# SERVICE BULLETIN

NON-MODIFICATION SERVICE BULLETIN — PNEUMATIC — BLEED AIR — TO APPLY CORRECT TORQUE VALUE TO IMPROPERLY TORQUED BLEED AIR AND STARTER DUCT COUPLINGS

# V2500-NAC-36-0009

The purpose of this Non-Modification Service Bulletin (NMSB) is to provide instruction to apply correct torque to improperly torqued couplings on the Pneumatic Bleed Air and Starter Ducts. Improperly torqued couplings may lead to pneumatic system leakages.

LOCATION OF THE COUPLINGS  
36-11-41, 36-11-49-, 36-11-51 and 36-11-52  
FIGURE 1, SHEET 1

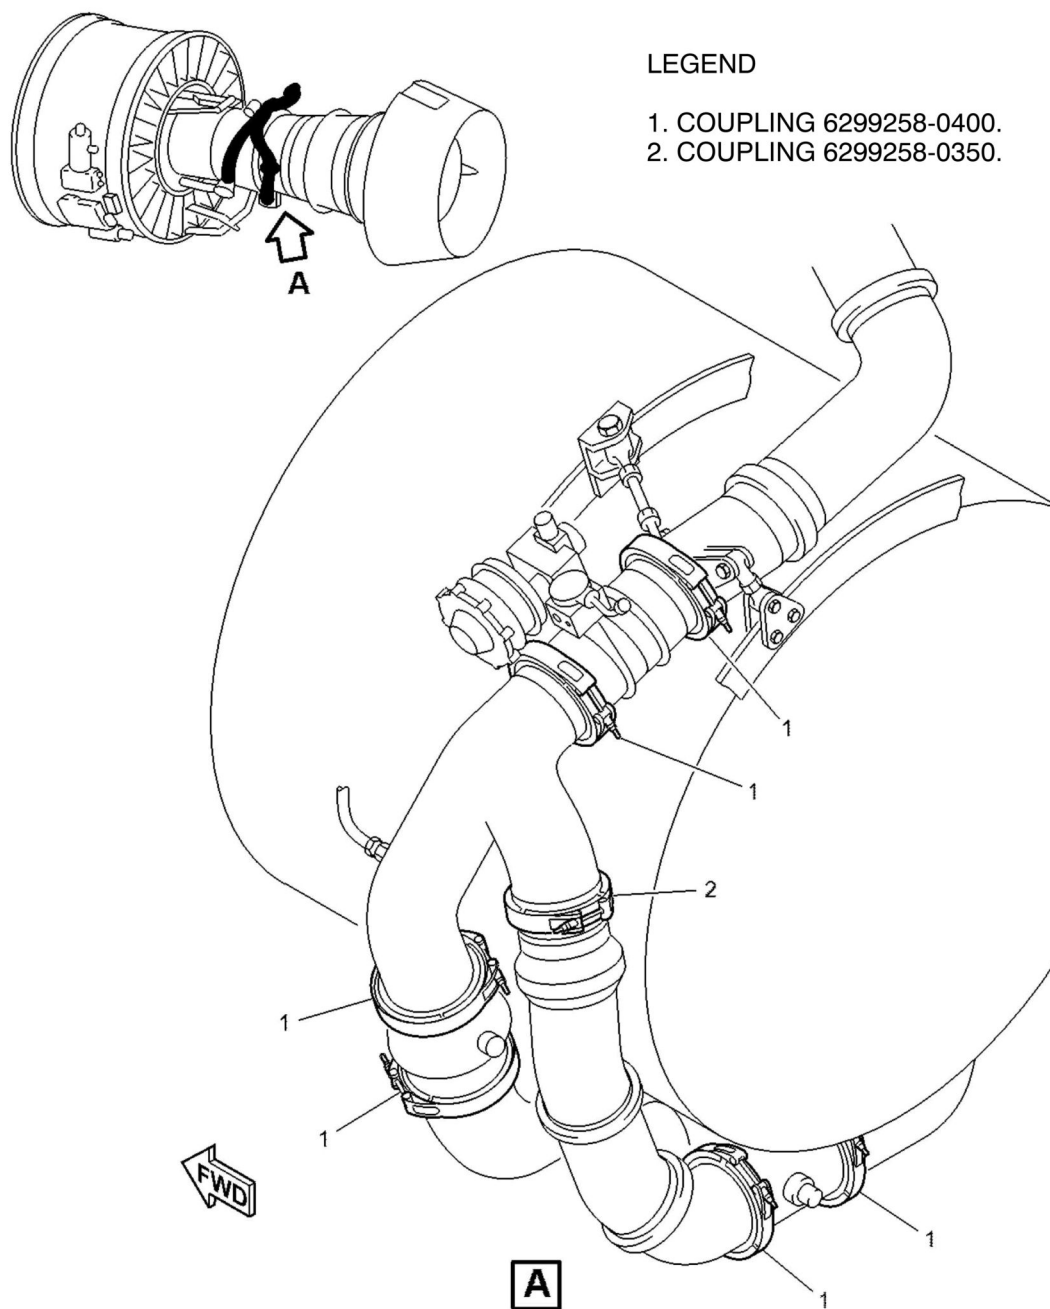
- A. Perform the Coupling nut, PN 6299258-0400 and 6299258-0350, re-torque procedure at seven (7) locations. Refer to Figure 1 Sheet 1.

- (1) Loosen the nut on the couplings (1) and (2).
- (2) Torque the nut on the couplings (1) and (2) to 75 – 85 lbf-in (8.47 – 9.60 N.m) as specified in Reference 1, V2500 Standard Practices Manual, P&W Ref. PN 2A4414, Chapter 70-41-00.
- (3) Hit the coupling lightly in several places around the perimeter of the clamp with a nonmetallic hammer to equally apply the band or segment tension.
- (4) Do Steps 2.A.(2) and 2.A.(3) again two (2) more times.
- (5) Final torque the nut on the couplings (1) or (2) to 75 – 85 lbf-in (8.47 – 9.60 N.m) as specified in Reference 1, V2500 Standard Practices Manual (SPM), P&W Ref. PN 2A4414, Chapter 70-41-00.

LOCATION OF THE COUPLINGS  
80-13-51  
FIGURE 1, SHEET 2

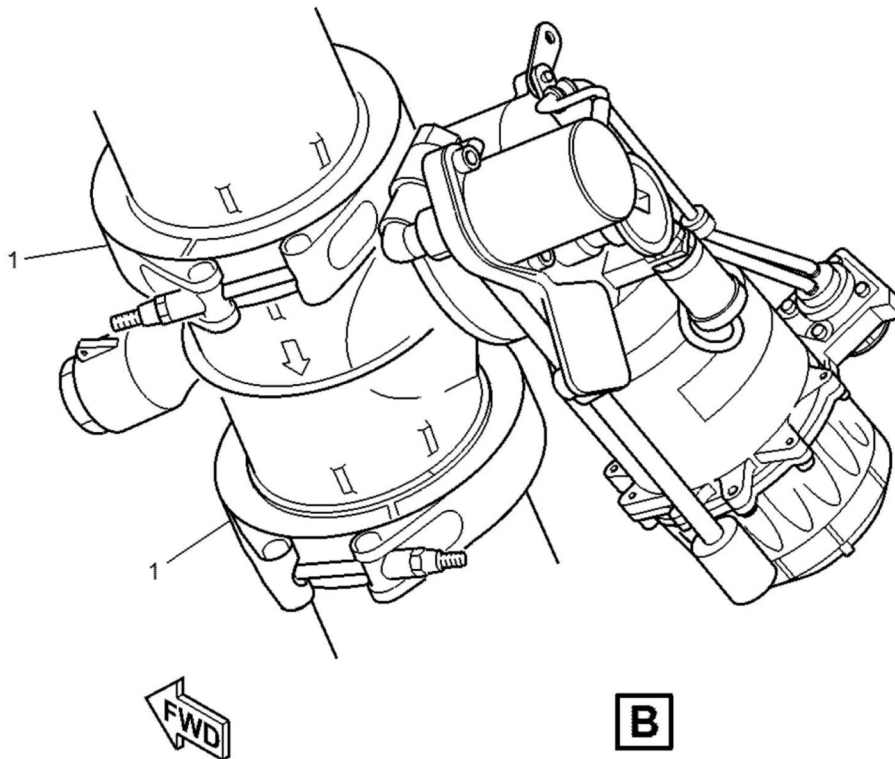
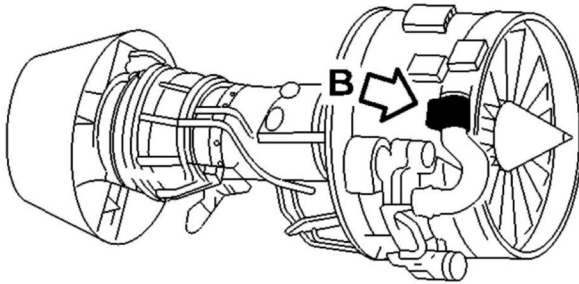
- B. Perform the Coupling nut, PN 6299258-0400 re-torque procedure at two (2) locations. Refer to Figure 1 Sheet 2.

- (1) On the pneumatic starter control valve, loosen the nut on the couplings (1).
- (2) Torque the nut on the couplings (1) to 75 – 85 lbf-in (8.47 – 9.60 N.m) as specified in Reference 1, V2500 Standard Practices Manual, P&W Ref. PN 2A4414, Chapter 70-41-00.
- (3) Hit the coupling lightly in several places around the perimeter of the clamp with a nonmetallic hammer to equally apply the band or segment tension.
- (4) Do Steps 2.B.(2) and 2.B.(3) again two (2) more times.
- (5) Final torque the nut on the couplings (1) to 75 – 85 lbf-in (8.47 – 9.60 N.m) as specified in Reference 1, V2500 Standard Practices Manual, P&W Ref. PN 2A4414, Chapter 70-41-00.

FIGURE 1, SHEET 3

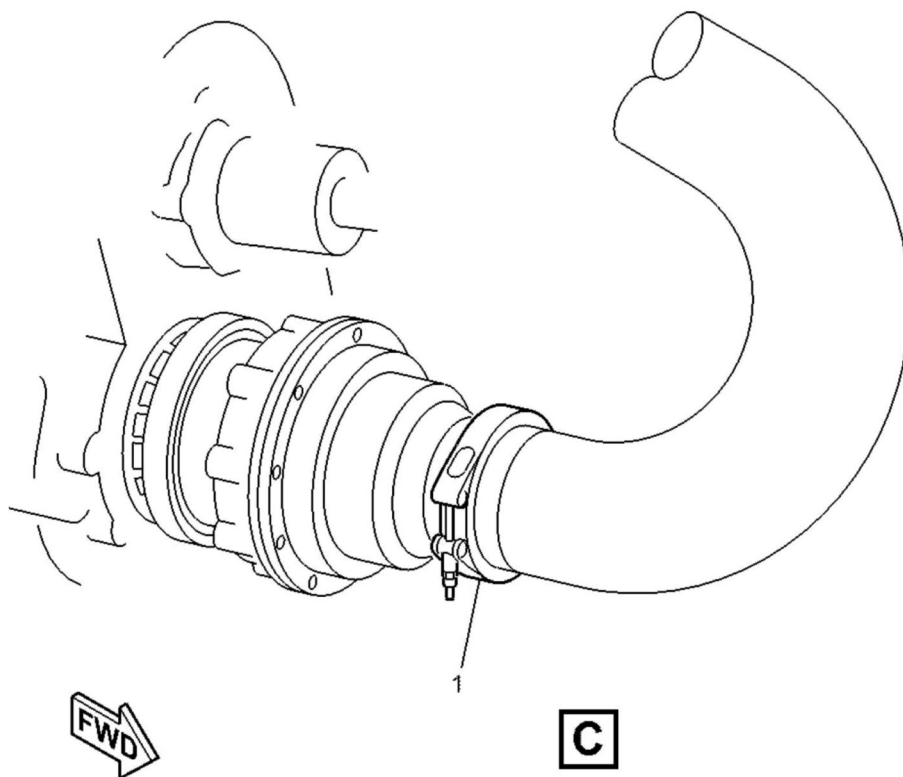
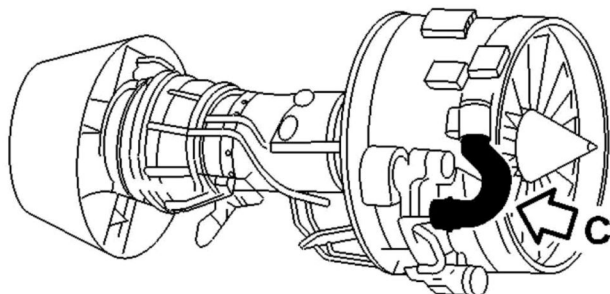
- C. Perform the Coupling nut, PN 6299258-0400 re-torque procedure at one (1) location. Refer to Figure 1 Sheet 3.

- (1) On the pneumatic starter, loosen the nut on the coupling (1).

- (2) Torque the nut on the coupling (1) to 75 – 85 lbf-in (8.47 – 9.60 N.m) as specified in Reference 1, V2500 Standard Practices Manual, P&W Ref. PN 2A4414, Chapter 70-41-00.

- (3) Hit the coupling lightly in several places around the perimeter of the clamp with a nonmetallic hammer to equally apply the band or segment tension.

- (4) Do Steps 2.C.(2) and 2.C.(3) again two (2) more times.
  - (5) Final torque the nut on the couplings (1) to 75 – 85 lbf-in (8.47 – 9.60 N.m) as specified in Reference 1, V2500 Standard Practices Manual, P&W Ref. PN 2A4414, Chapter 70-41-00.
